ADDENDUM NO. 1

DATE: 09/16/24

Child Nutrition Kitchen
726 South Pine St.
Madera, California 93637

DARDEN PROJECT NO. 2310
City of Madera Application #19876

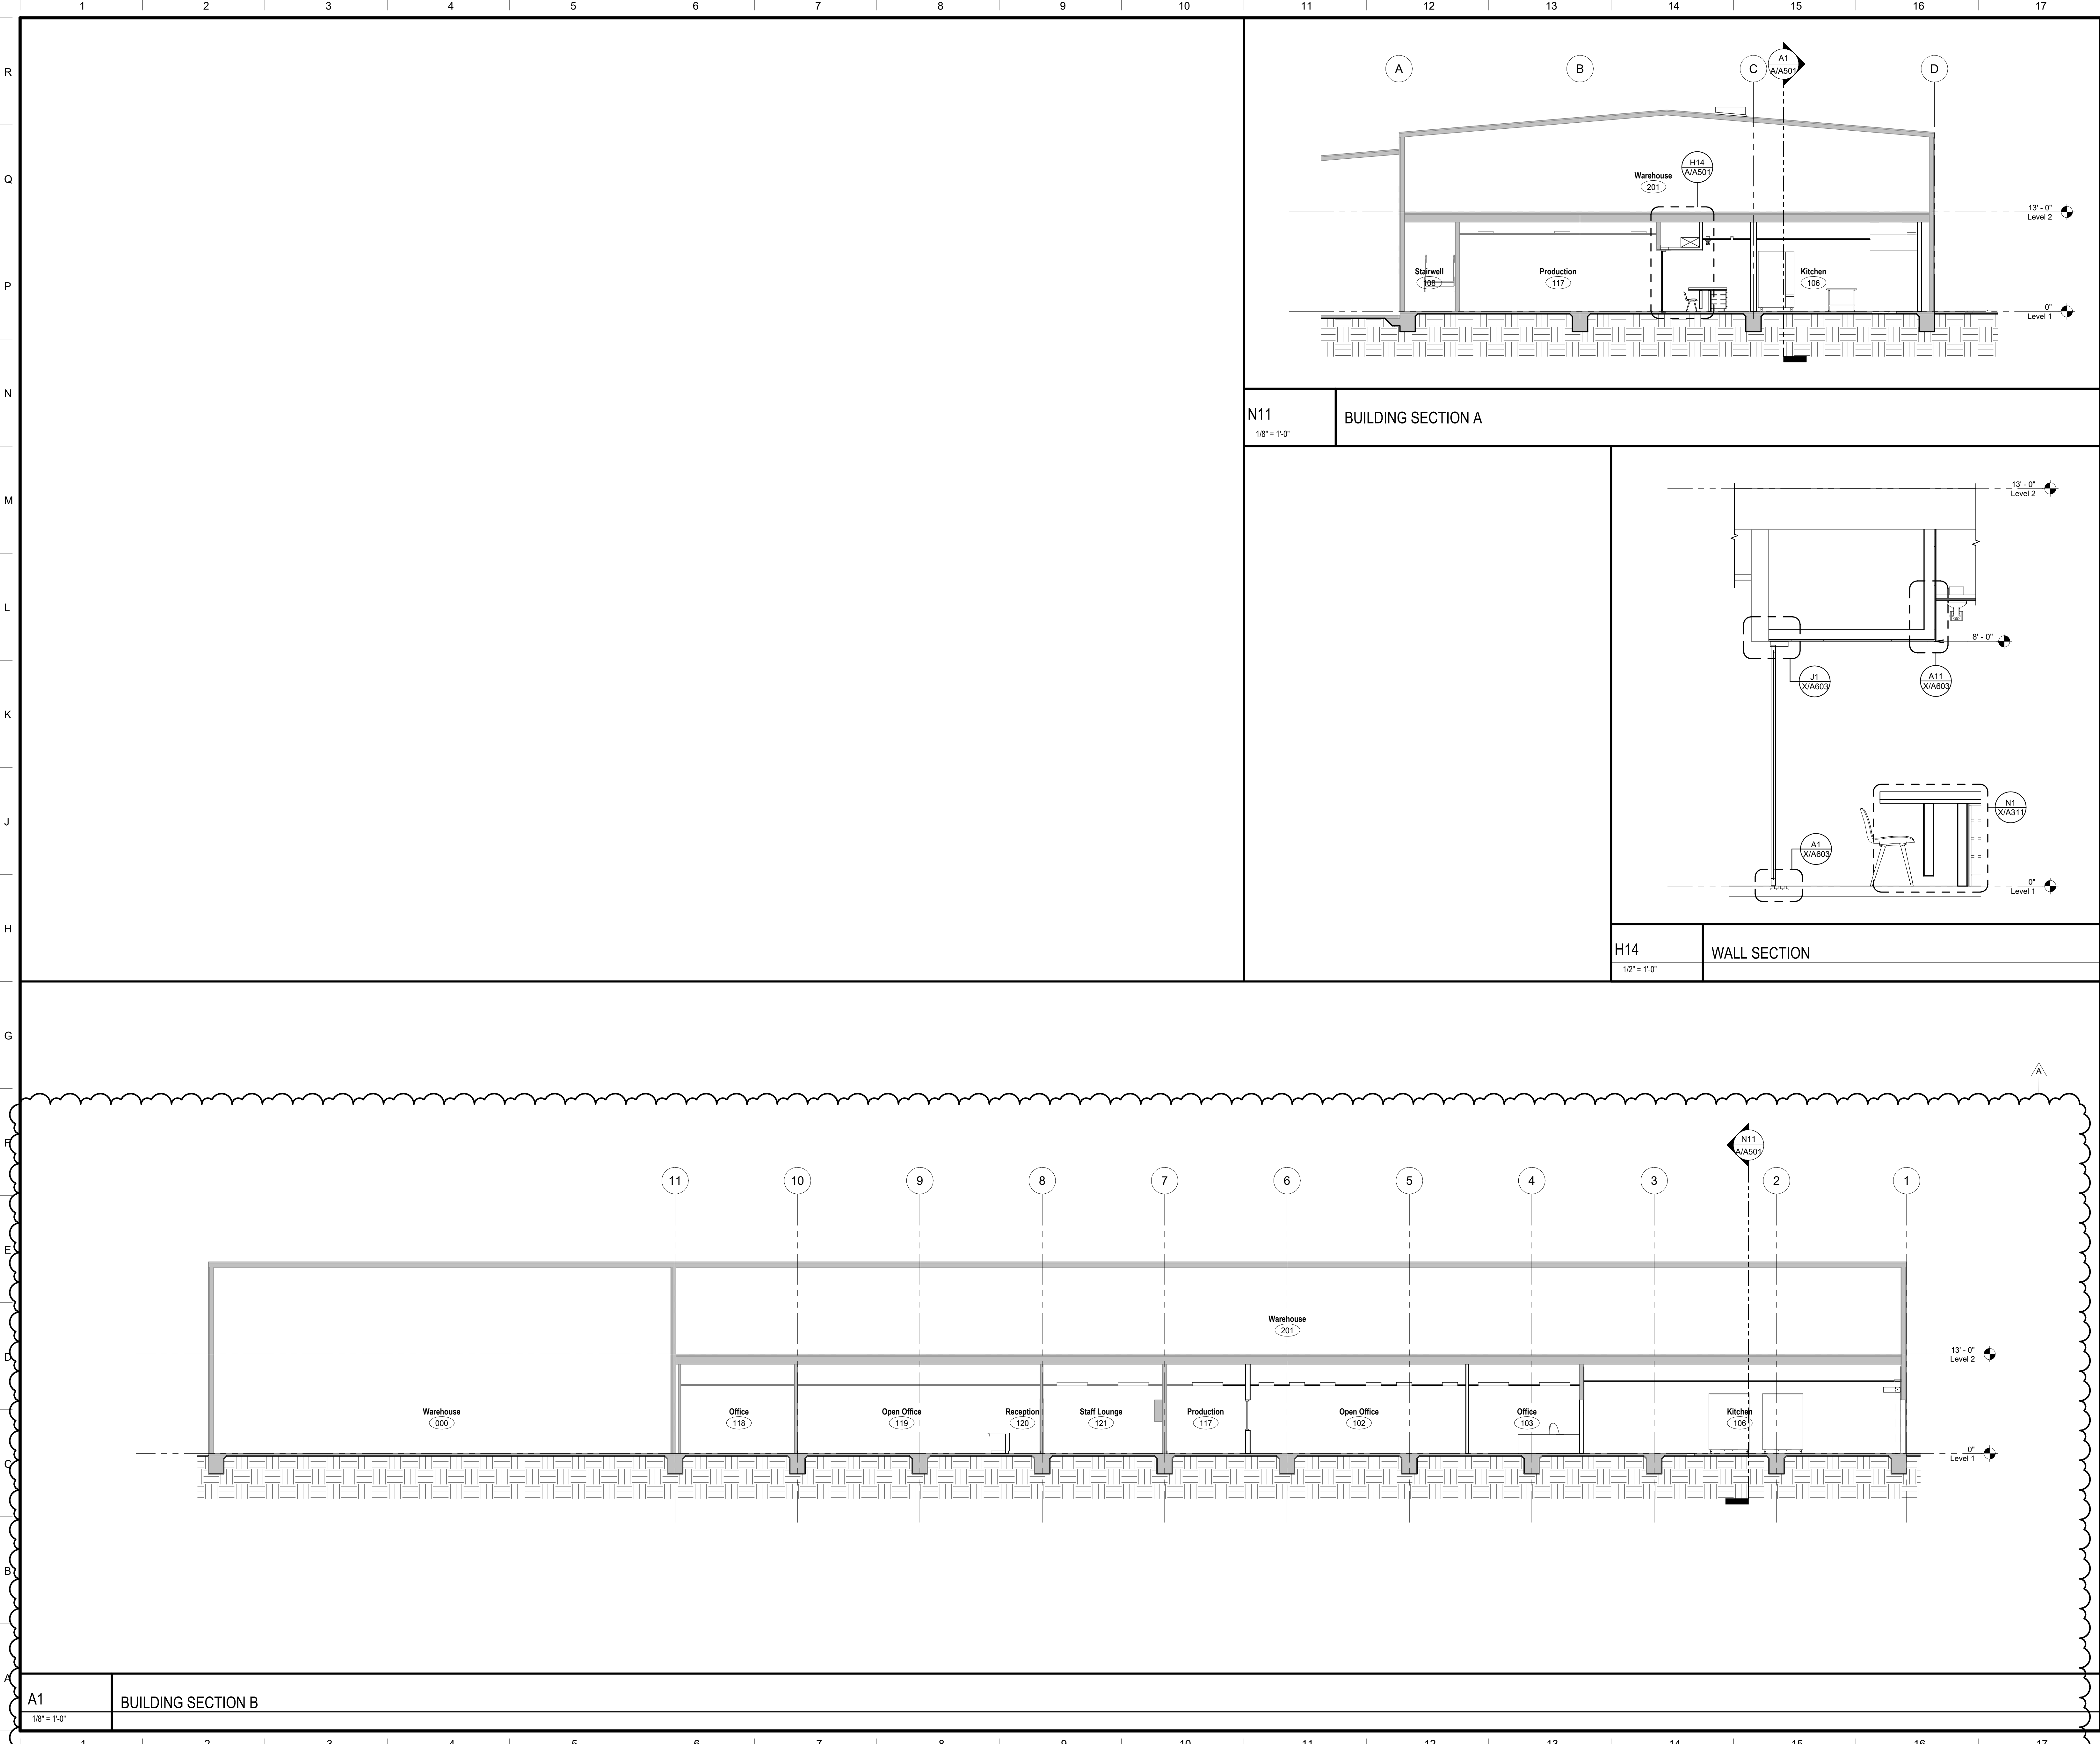
AD1-A08 Refer to Sheet A/A301, ROOF PLAN:

1. Replace sheet with attached exhibit AD1-AX08
 1. North/South section reference added.
 2. "See Mechanical drawings for equipment and weight." Added to roof curb notes.
